## Addendum # 1 File # 16-0264 (16-06AA) Project: Foundation Work for Leif Erikson Viking Ship Enclosure

# ADDENDUM NO. 1

Leif Erikson Viking Ship Enclosure Foundation Bid Package

#### **Attached: Geotechnical Borings**

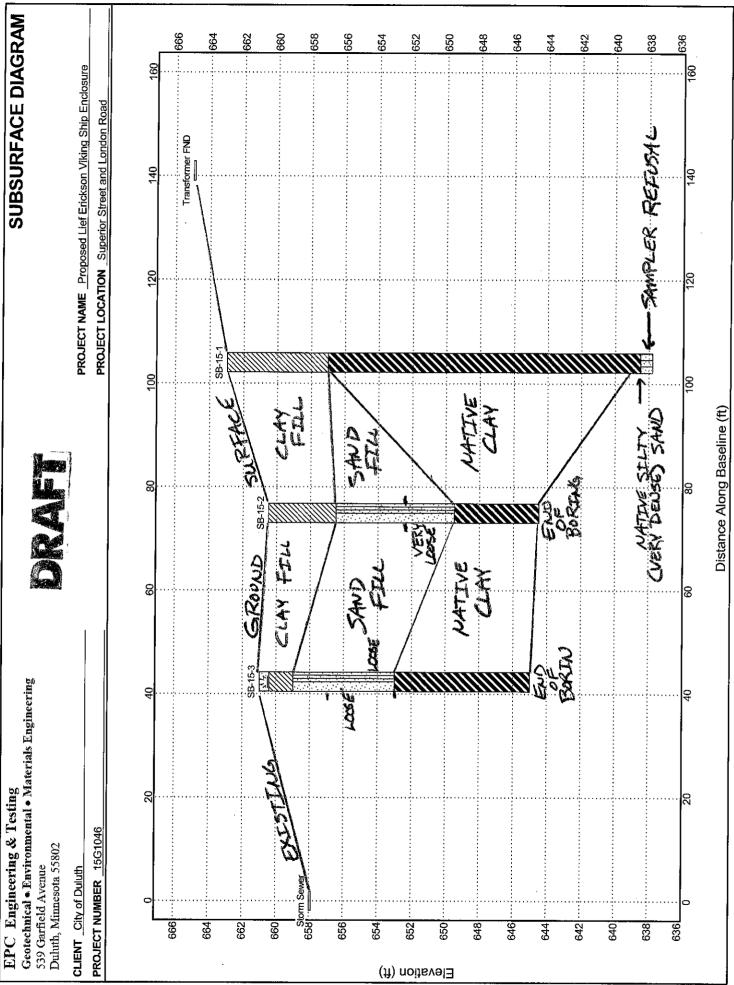
- S001: Notes in Foundation and Subgrade section indicate bedrock is anticipated at 25'-0" below elevation 664'-0". Notes in Helical Anchor section indicate a minimum of 15'-0" or as necessary to achieve load. *Geotechnical borings are attached* for clarity of anticipated soil profile; bearing on bedrock is assumed to be required so bidders should anticipate approximately 25'-0" as a minimum to bear on bedrock. Alternate helical pile layouts/arrangements will not be accepted.
